**Juneau Access Improvements Project
Final Supplemental
Environmental Impact Statement**

**2014 Update to Appendix O
Wetlands Technical Report
*2017 Errata***

2014 Update to Appendix O – Wetlands Technical Report

ERRATA

Exhibit 2. 2014 aerial imagery, JAI wetland mapping, and 2004 ShoreZone mapping of the Katzehin Ferry Terminal site.

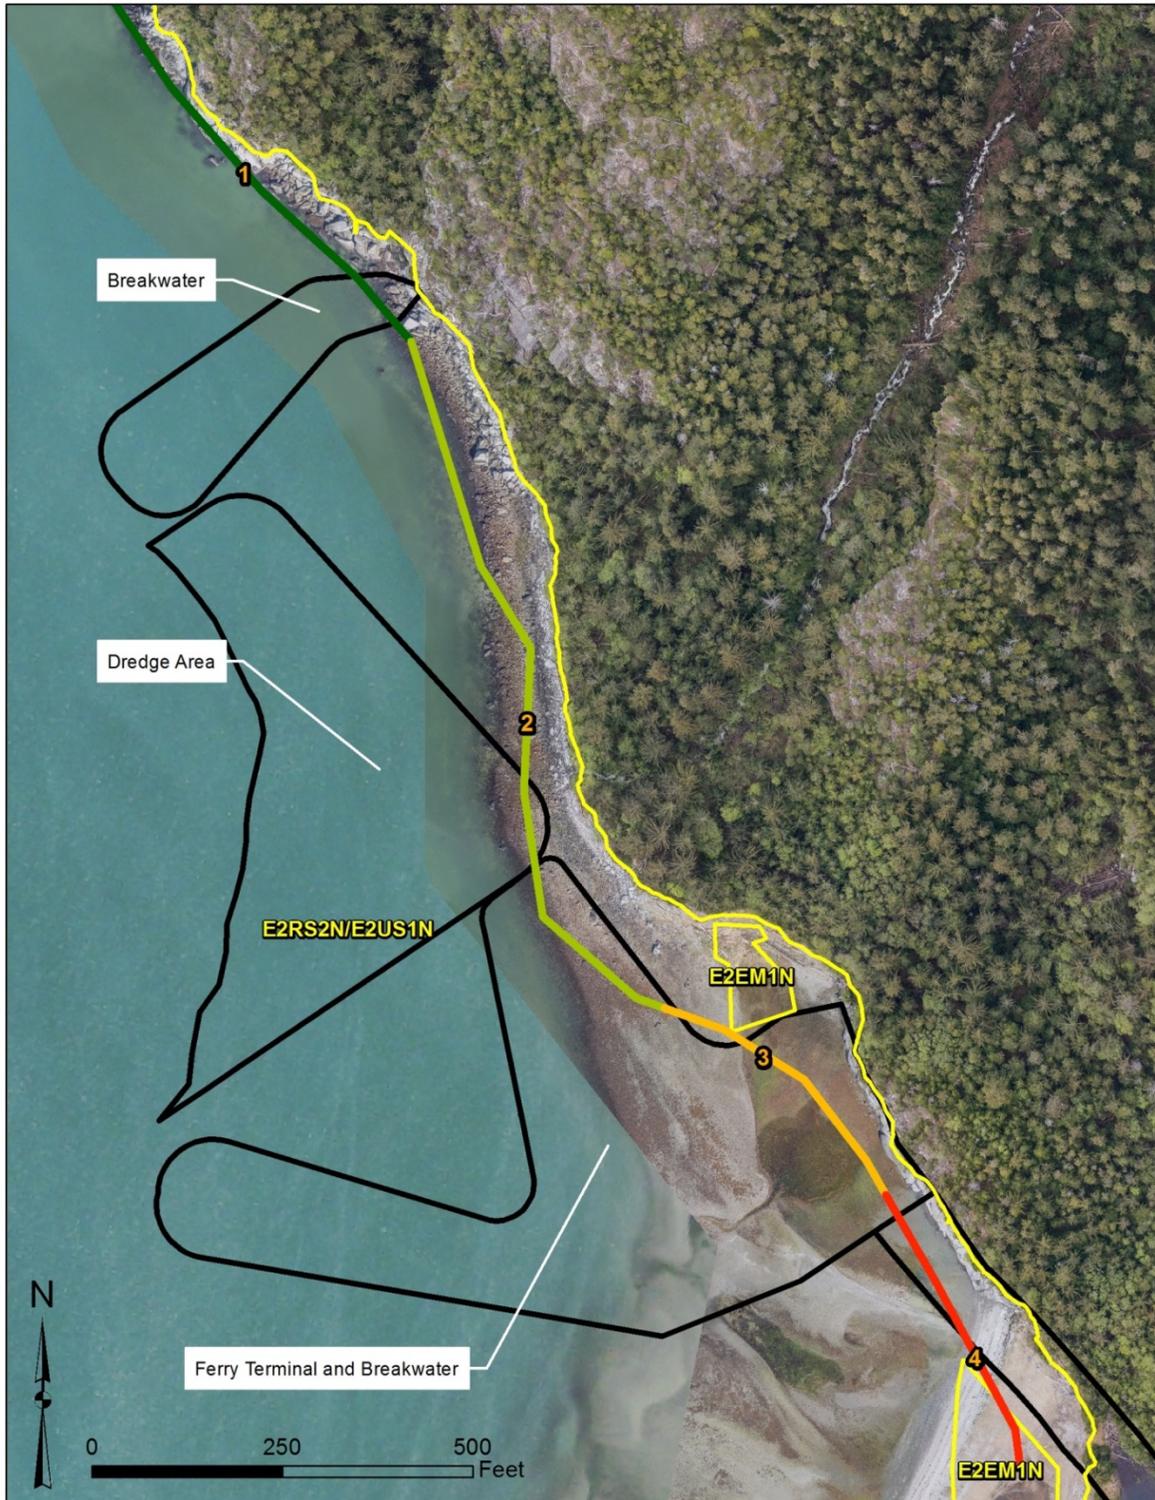
In the U.S. Army Corps of Engineers' (USACE) comment letter dated November 25, 2014 on the Draft Supplemental Environmental Impact Statement (DSEIS) for the Juneau Access Improvements (JAI) Project, the USACE requested more information on the potential presence of mudflats in and adjacent to the proposed Katzeihin River bridge and the Katzeihin Ferry Terminal location (USACE 2014). The U.S. Environmental Protection Agency (USEPA) similarly noted the potential for mudflats along the south shore of the Katzeihin River in their comment letter, also dated November 25, 2014 (USEPA 2014). The purpose of this memorandum is to examine the potential for mudflats or other special aquatic sites within these two areas using newly available information.

Exhibit 2 shows the Katzechin Ferry Terminal site along with the 2014 aerial imagery, the 2014 JAI wetland mapping, and the 2004 ShoreZone classification (NOAA 2014). The relevant ShoreZone mapping codes are described in Table 1.

Rocks and gravels are visible in the 2014 aerial photography and in the ShoreZone photograph (Exhibit 3) throughout the area where the proposed ferry terminal would be sited. The shore types mapped by ShoreZone generally describe rocky/gravel beaches. No part of the Katzechin Ferry Terminal area is mapped as mudflat by ShoreZone (NOAA 2014). One section of ShoreZone mapping (ID# 3) identifies organics and fines in its mapping. This code represents vegetation and fines that can be located either in the intertidal or supratidal region. Additional information from the ShoreZone website was collected for the across-shore components of this area (Table 2; NOAA 2014). This mapping zone (ShoreZone ID# 3) covers an area mapped as E2EM1N in the DSEIS and USACE permit application.

The discontinuous marsh documented in the third across-shore component of ShoreZone ID# 3 accounts for the emergent estuarine wetland currently mapped. Rocks and gravel are present in all across-shore components in all areas where the proposed ferry terminal would be located. The smallest particle size mapped by ShoreZone in the area is sand.

Rocks and gravel are visible throughout the area on the 2014 aerial photography. The ShoreZone mapping does not identify mudflats and classifies the area as being dominated by pebbles and sand. Consequently, this area would not meet the definition of mudflats and therefore would not be characterized as a special aquatic site according to Section 404(b)(1) Guidelines (40 CFR Part 230).

Exhibit 4. 2014 aerial imagery, JAI wetland mapping, and 2004 ShoreZone mapping of the Katzehin River bridge southern embankment.

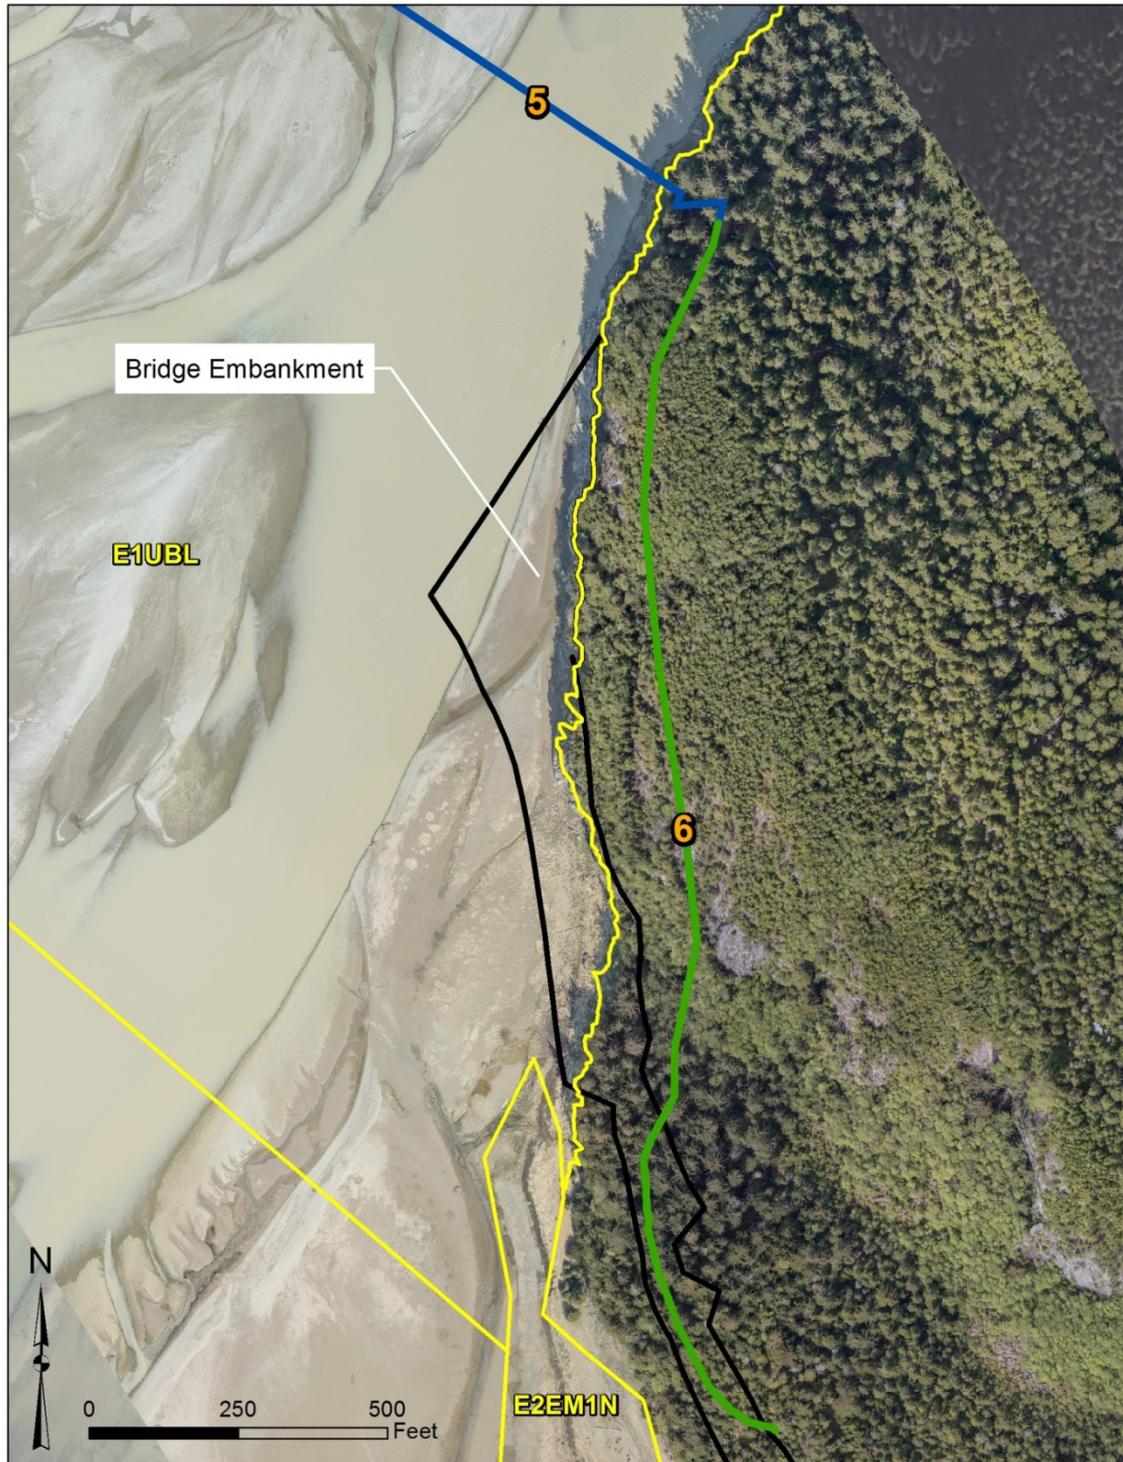
Exhibit 4 shows the southern embankment for the Katzeihin River bridge with the 2014 aerial photography and the 2004 ShoreZone mapping. No part of the Katzeihin River south shore embankment is mapped as mudflat by ShoreZone (NOAA 2014). The ShoreZone mapping near the proposed embankment is described in Table 3. Two ShoreZone types are mapped in the area, both describing the area as sand flats.

Additional information from the ShoreZone website was collected for the across-shore components of the two ShoreZone types (Table 4; NOAA 2014). These components are described in Table 4. Aside from the cliff component on ShoreZone ID# 6, all other components list sand before mud or fines, meaning that sand is present in greater abundance than mud or fines. Rocks and gravel are visible on the 2014 aerial imagery directly adjacent to the river channel and sporadically throughout the entire area that would be impacted.

Due to the presence of rocks and gravel visible on the 2014 aeriels and the classification of the area as sand flats by ShoreZone, this area would not meet the definition of mudflats and therefore would not be characterized as a special aquatic site according to Section 404(b)(1) Guidelines (40 CFR Part 230).
